Access Compliance Report

Public Rights-of-Way

(Curb Ramps)

Intersection ID: N/A	Main Street: SPEER_BV	Cross Street: MILLENNIUM_AV	Location: NE
ADA ID: 315C64242AA0	Ramp Type: Perp	Initial Pass/Fail: Fail	Overall Compliance: No
Severity Score: 21.25			
Codes/Mitigation Info/Possible Solution		Field Measurements/Component Compliance

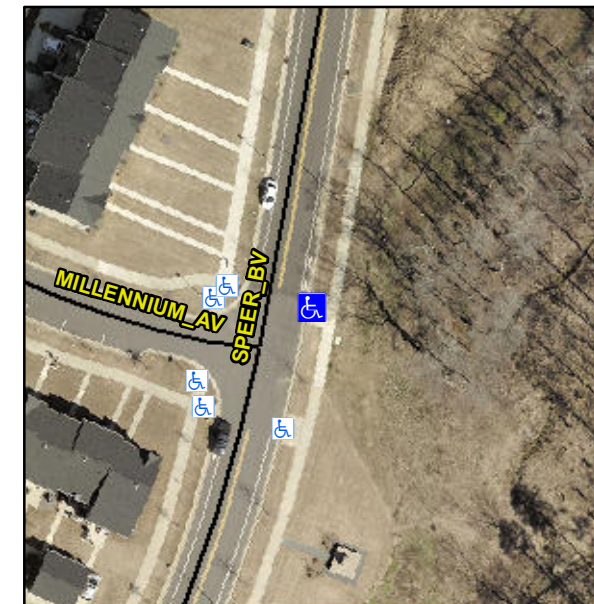
R304.5.1, R304.2.2

Compliance	Description	Data	Compliance	Description	Data
N/A	Ramp Length (in)	94.0	No	Ramp Slope (%)	10.5
No	Ramp Width (in)	46.5	Yes	Ramp XSlope (%)	0.1
N/A	Flare Type LT	N/A	N/A	Flare Type RT	N/A
N/A	Flare Slope LT (%)	N/A	N/A	Flare Slope RT (%)	N/A
N/A	Flare Traversable LT?	N/A	N/A	Flare Traversable RT?	N/A
N/A	Landing Length (in)	N/A	N/A	DWS Provided?	N/A
N/A	Landing Width (in)	N/A	N/A	DWS Contrast?	N/A
N/A	Landing Slope (%)	N/A	N/A	DWS Length (in)	N/A
N/A	Landing X Slope (%)	N/A	N/A	DWS Full Width?	N/A
N/A	Landing Curb? (Y/N)	N/A	N/A	DWS Offset (in)	N/A
N/A	Shared Landing?	N/A			
N/A	Gutter Ponding?	N/A	N/A	Gutter Slope (%)	N/A
N/A	Gutter Lip Ht (in)	N/A	N/A	Gutter X Slope (%)	N/A
N/A	Painted X Walk1?	No	N/A	Painted X Walk2?	N/A
	X Walk 1 Direction	To W		X Walk 2 Direction	N/A
N/A	X Walk 1 Width (in)	N/A	N/A	X Walk 2 Width (in)	N/A
	X Walk 1 Slope (%)	3.1		X Walk 2 Slope (%)	N/A
	X Walk 1 X Slope (%)	0.8		X Walk 2 X Slope (%)	N/A

Remove & Replace Entire Ramp.
